STATE OF OHIO
CITY OF CANTON
STA-0153-01.70
MAHONING ROAD NE
ROADWAY IMPROVEMENTS
G.P. 1103

THE PROJECT WORK INVOLVES THE IMPROVEMENT OF APPROXIMATELY 0.67 MILES OF MAHONING ROAD NE, S.R. 153 BETWEEN THE GRACE AVENUE NE AND HARMONT AVENUE NE INTERSECTIONS. THE IMPROVEMENTS INCLUDE NEW STORM SEWERS, CURBS, SIDEWALKS, PLANTERS, SIGNAGE, AND STREET LIGHTING.

REVISIONS	DATE	BY
CONSTRUCTION BIDDING SET	4/21/14	GEA
ADDENDUM NO. 1	5/7/14	GEA

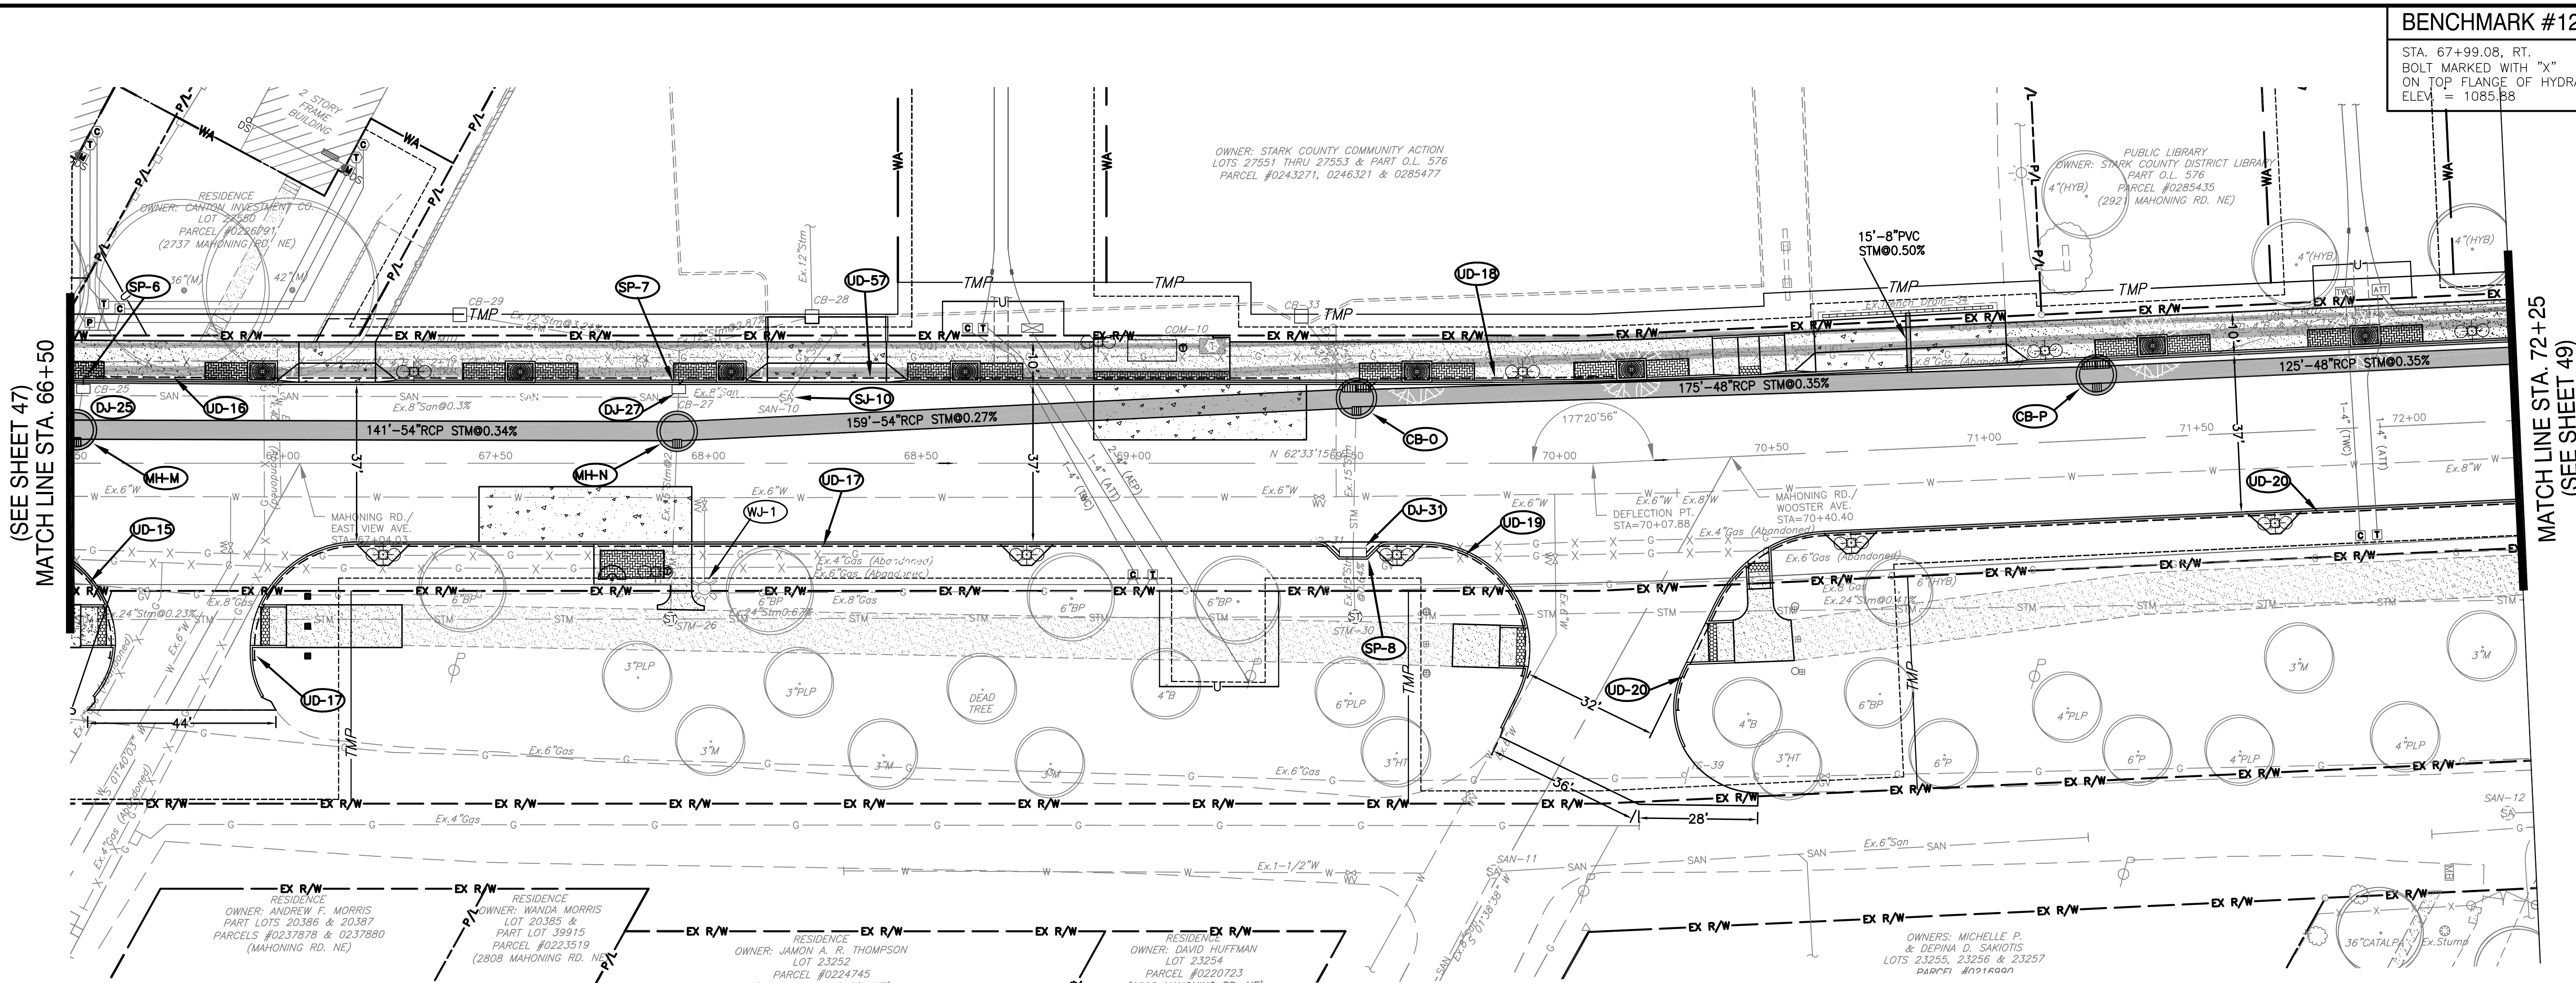
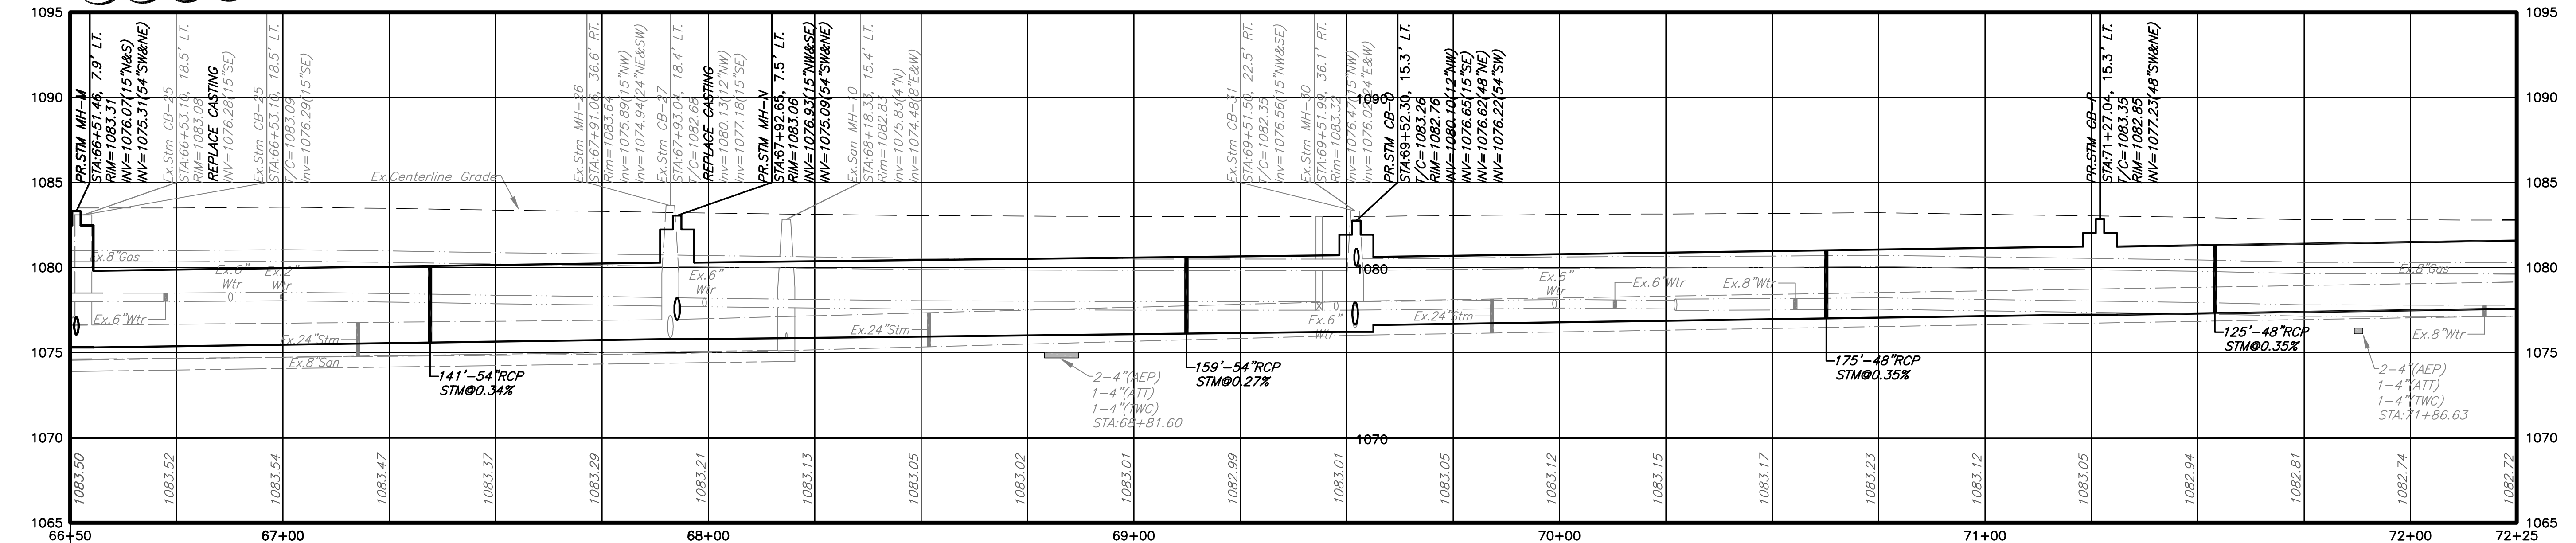
REVISIONS TO THIS SHEET INCLUDED:
 • ADDED ADDITIONAL CALL OUT ITEMS TO MATCH SUB-SUMMARY TABLES ON SHEETS 21 THRU 40.
 • REVISED HATCHING DESIGNATING DIFFERENCE BETWEEN DRIVE APRONS AND SIDEWALK.

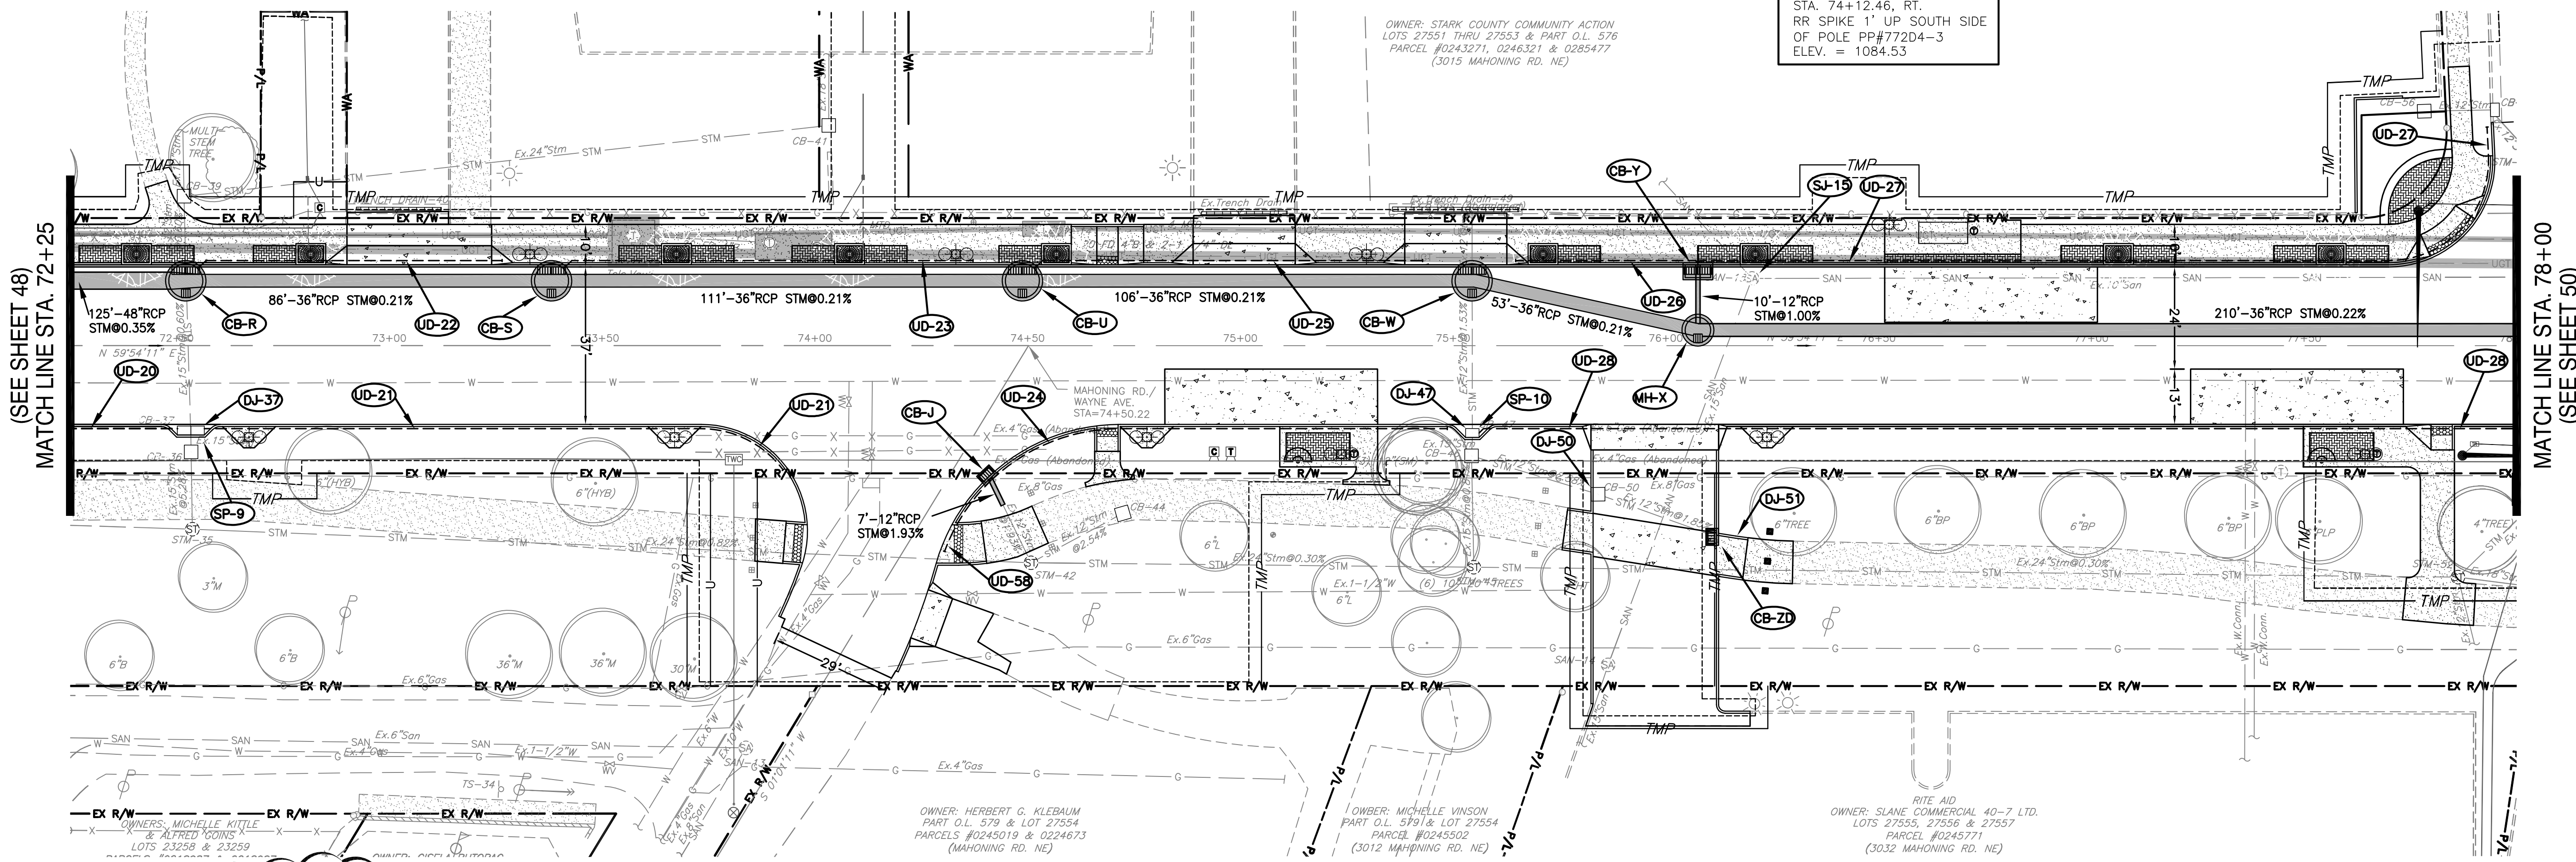
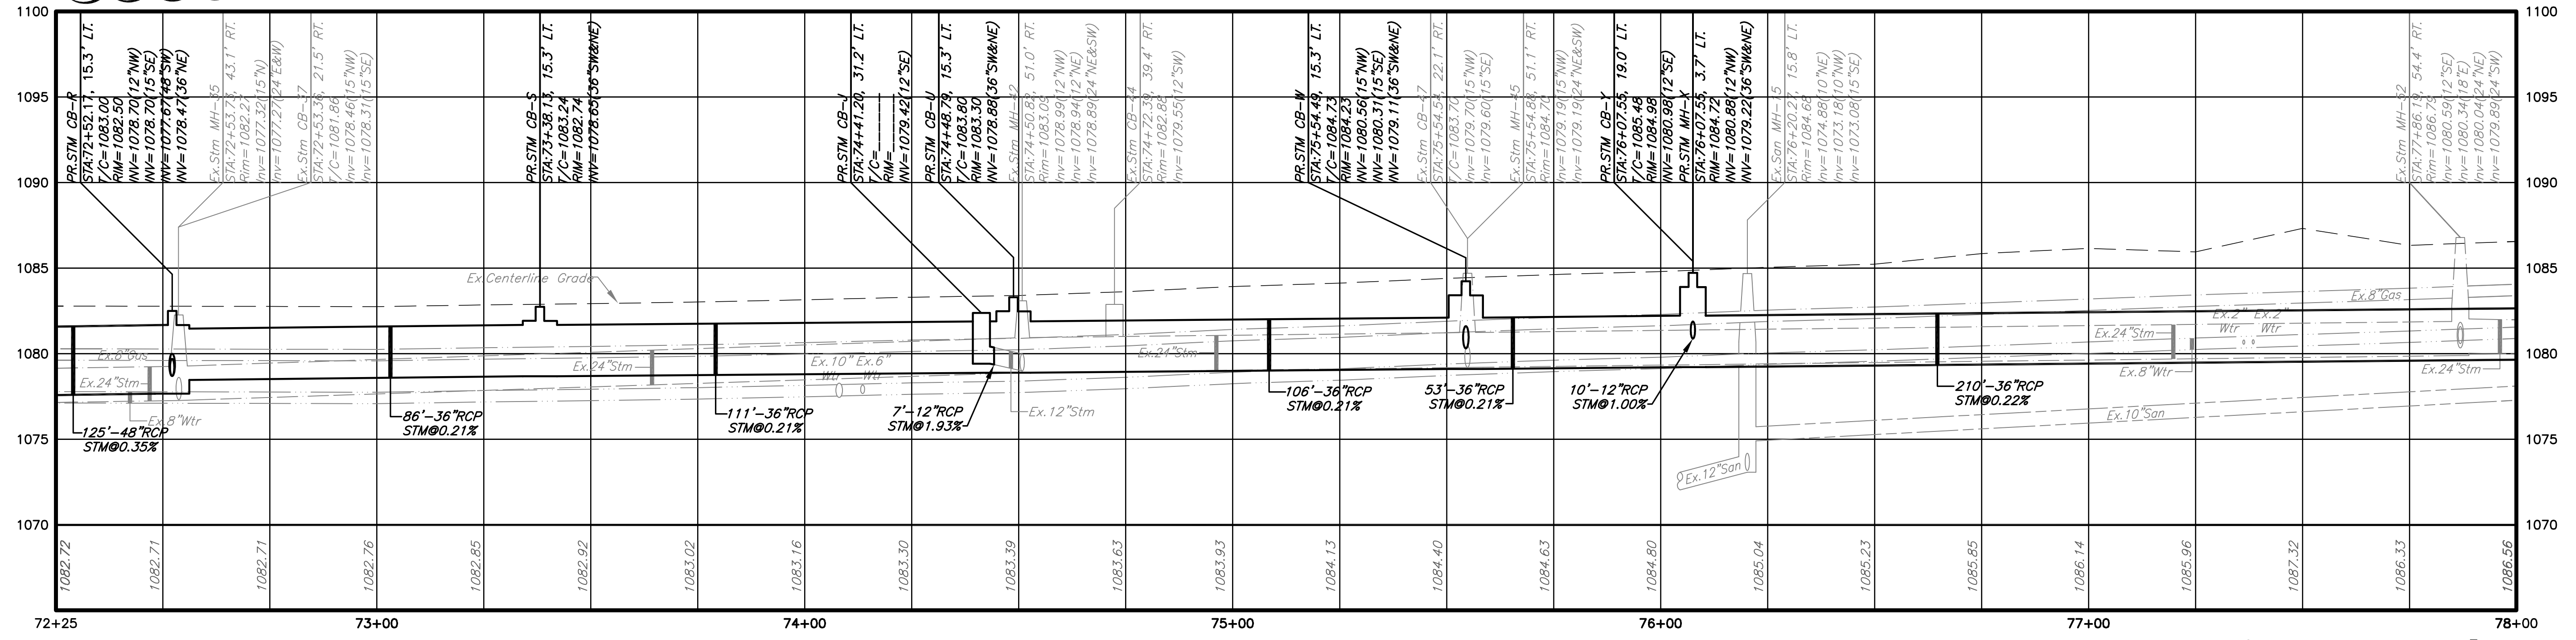
REVISIONS TO THIS SHEET INCLUDED:
 • ADDED ADDITIONAL CALL OUT ITEMS TO MATCH SUB-SUMMARY TABLES ON SHEETS 21 THRU 40.
 • REVISED HATCHING DESIGNATING DIFFERENCE BETWEEN DRIVE APRONS AND SIDEWALK.
